UNITED STATES PATENT AND TRADEMARK OFFICE

10/598,052

Office Action Summary	Application No.	Applicant(s)	
	10/598,052	GROENINGER, HORST	
	Examiner	Art Unit	
	Paresh Patel	2829

DETAILED ACTION

Figure 3

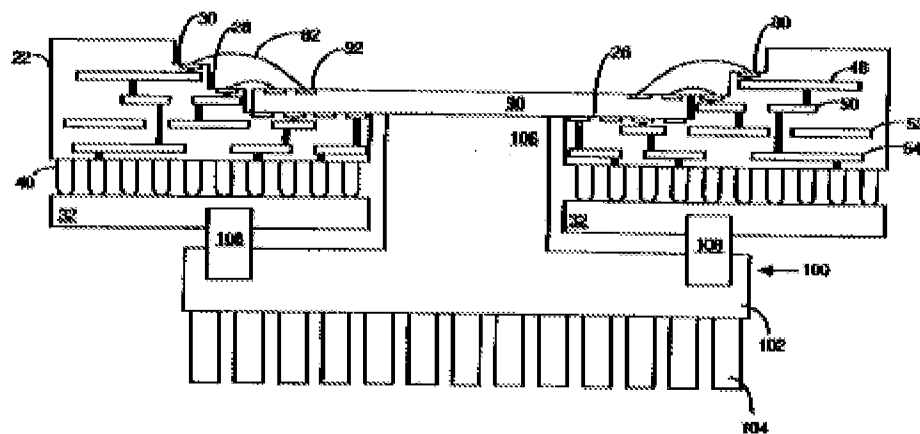
Regarding claims 38 and 48, Malladi et al. (hereafter Malladi) in fig. 3, as shown below, discloses a test apparatus for testing a semiconductor device, where the test apparatus comprising:

a test socket **[22]** mounted on a test printed circuit board **[32]**, where the test socket has a locating seat **[portion of 22 for 90]** for locating the top of the semiconductor device, and where the region of the locating seat contains internal through-contact elements **[electrical path of 22 below the element 90]** through the test socket to the test printed circuit board in order to make an electrical connection between the contact pads of the top of the semiconductor device and the contact pads of the test printed circuit board; a stamp (means for stamping of claim 48) **[see “clamps” for element 108]**; and where the test socket (means for providing external through-contact elements which are arranged outside of the locating seat and which make an electrical connection between contact pads on the test printed circuit board and contact pads on the back of the semiconductor device of claim 48) has external through-contact elements **[electrical path between wire bonding pads and 32]** which are arranged outside **[see the fig. 3]** of the locating seat and which make an electrical connection between contact pads on the test printed circuit board and contact pads on the back of the semiconductor device.

Apparatus of Malladi is capable making electrical contact between the semiconductor device having contact pads on its top and contact pads on its back, as intended by limitation of the claim, because test socket 22 has pads for electrical connection to said semiconductor device. Patel et al. discloses semiconductor device with pads on top and bottom, see BGA device with integrated circuit.
